December 23, 1996  
IPN-96-128

Subject: **Indian Point 3 Nuclear Power Plant**  
**Docket No. 50-286**  
**Proposed Technical Specification Changes**  
**Associated With the Upgrade to VANTAGE + Fuel**

**APPLICATION FOR AMENDMENT TO OPERATING LICENSE**

This application for amendment seeks to revise several sections of Appendix A of the Indian Point 3 Technical Specifications to accommodate the transfer from VANTAGE 5 (without intermediate flow mixers) fuel to VANTAGE + fuel.

FIGURE 2.1-1

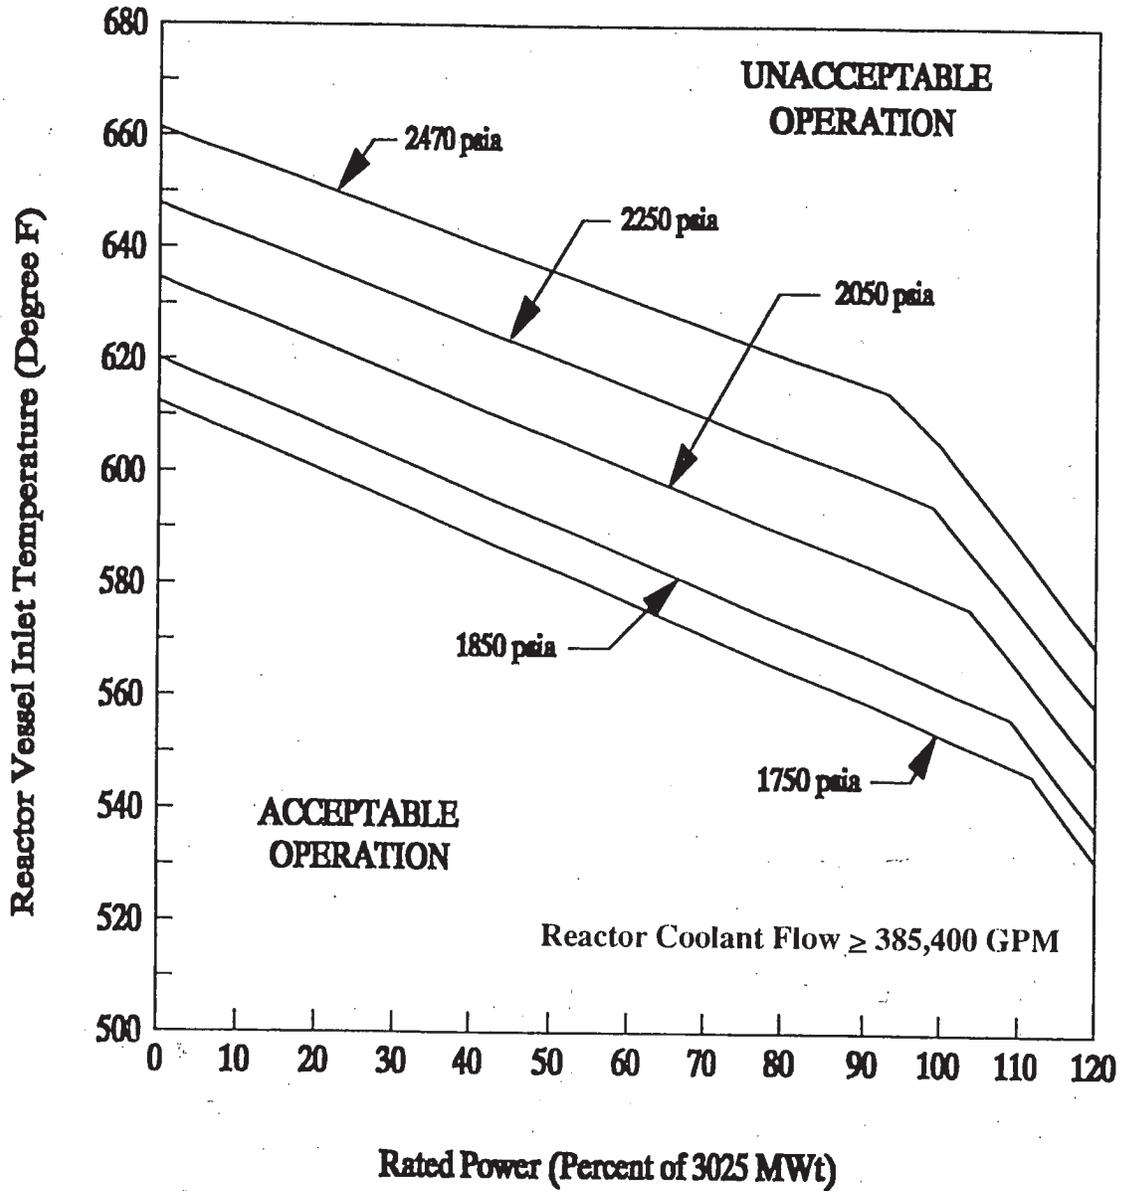
The combination of thermal power level, coolant pressure, and coolant temperature shall not exceed the limits shown in Figure 2.1-1 for four-loop operation. The safety limit is exceeded if the point defined by the combination of Reactor Coolant System vessel inlet temperature and power level is at any time above the appropriate pressure line.

The curves of Figure 2.1-1 show the loci of points of thermal power, Reactor Coolant System pressure and vessel inlet temperature for which the calculated DNBR is no less than the Safety Limit DNBR value or the average enthalpy at the vessel exit is less than the enthalpy of saturated liquid.

Figure 2.1-1 includes an allowance for an increase in the enthalpy rise hot channel factor at reduced power based on the expression:

**Figure 3.1**  
**Comparison of Radial Peaking Factors for Cycle 9**  
**and Transition Cycles**

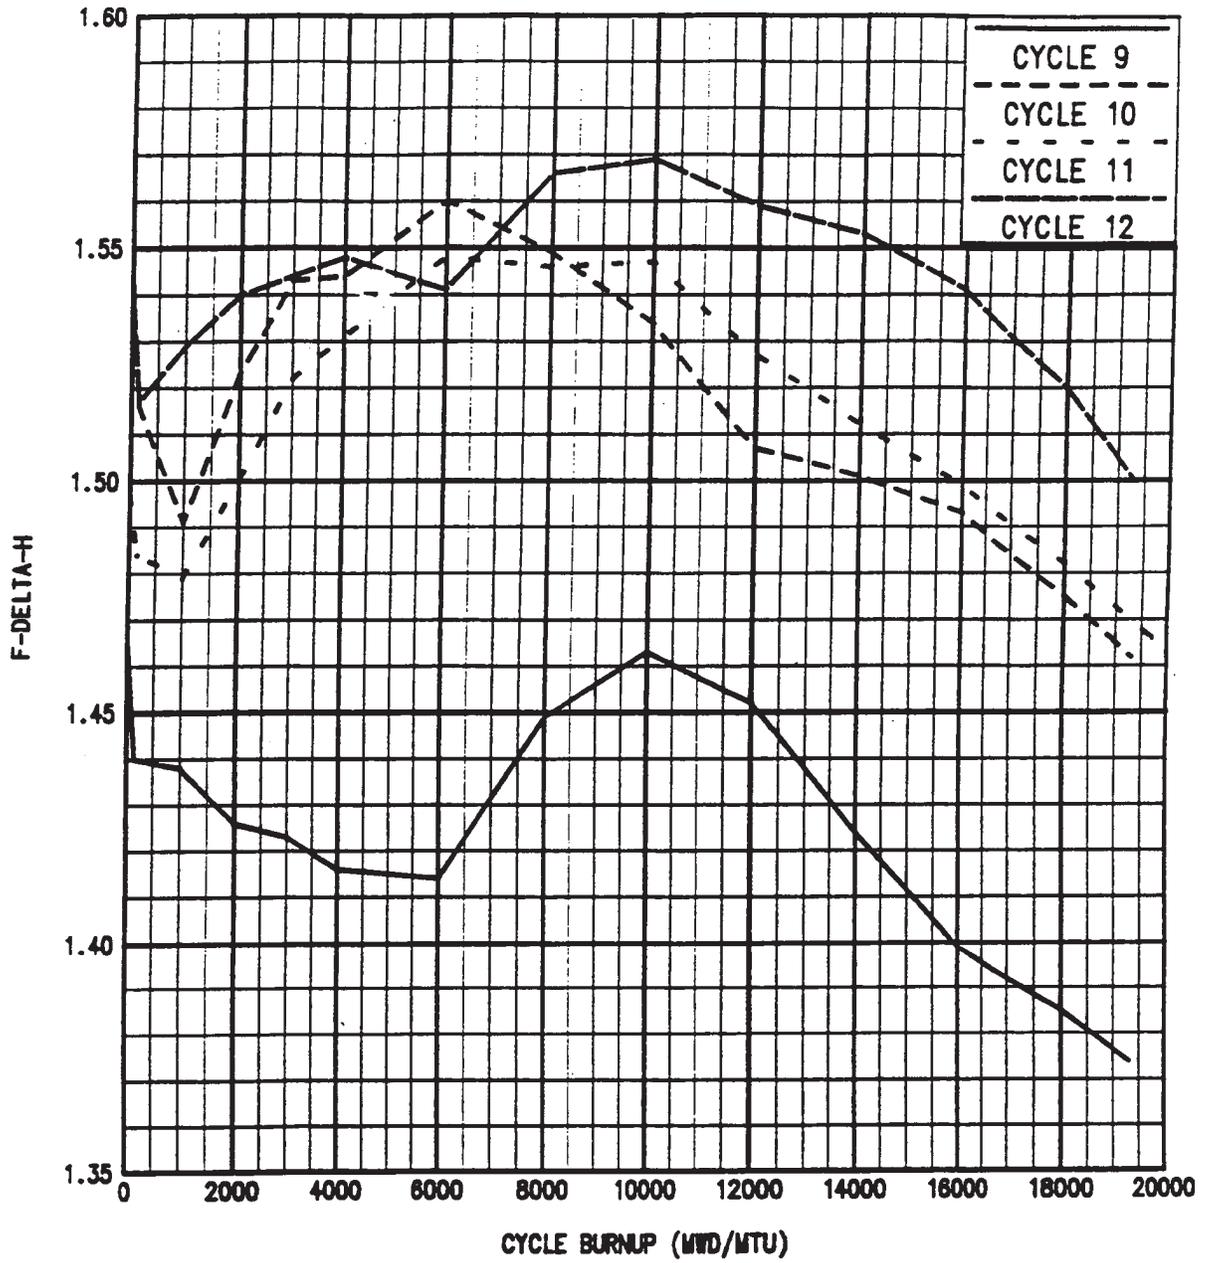
Figure 3.1 shows a comparison of the radial peaking factors between the Cycle 9 design (designed to the current radial peaking factor limit, used reduced length enriched B-10 loading burnable absorbers and solid natural axial blankets) and typical core models beginning with Cycle 10 (designed to the higher peaking factor limits and used 6 inch annular axial blankets and reduced length enriched IFBAs). The increased radial peaking factor is expected and results from the reduced power carried by the more highly burned assemblies placed on the core periphery to reduce neutron leakage.

Figure 3.2

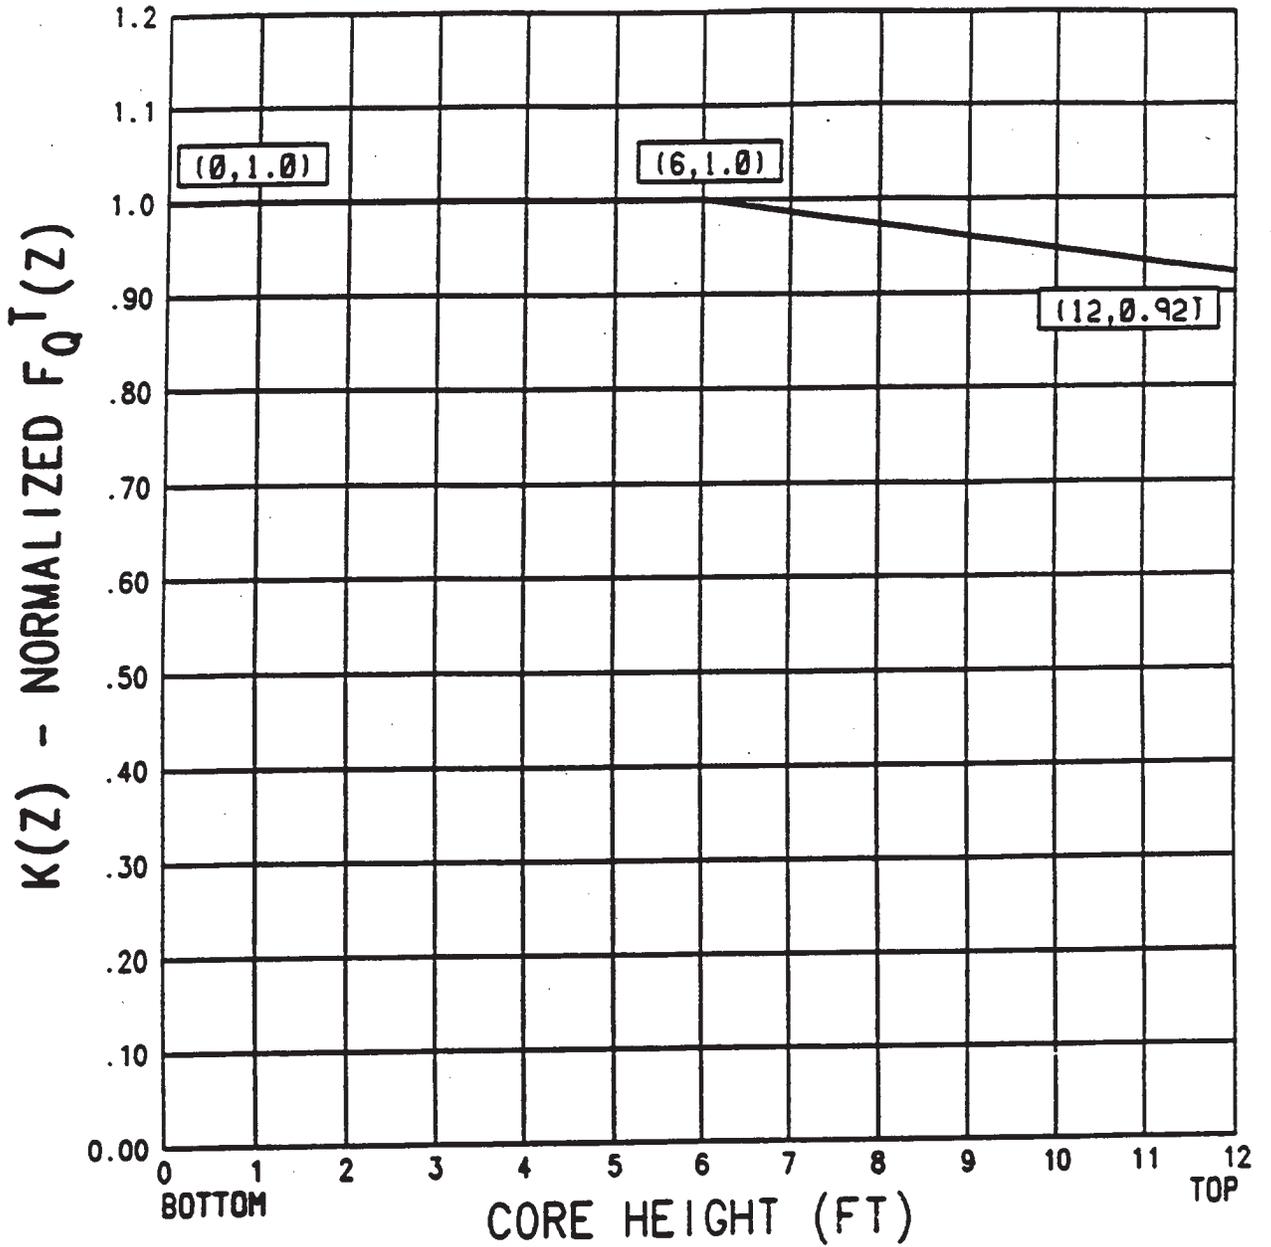
The  $F_Q$  limit will be increased to 2.42 using a two segment K(2) curve as shown in Figure 3.2. This provides greater flexibility with regard to accommodating axially heterogeneous cores incorporating such features as annular axial blankets and reduced length enriched B-10 loading burnable absorbers.
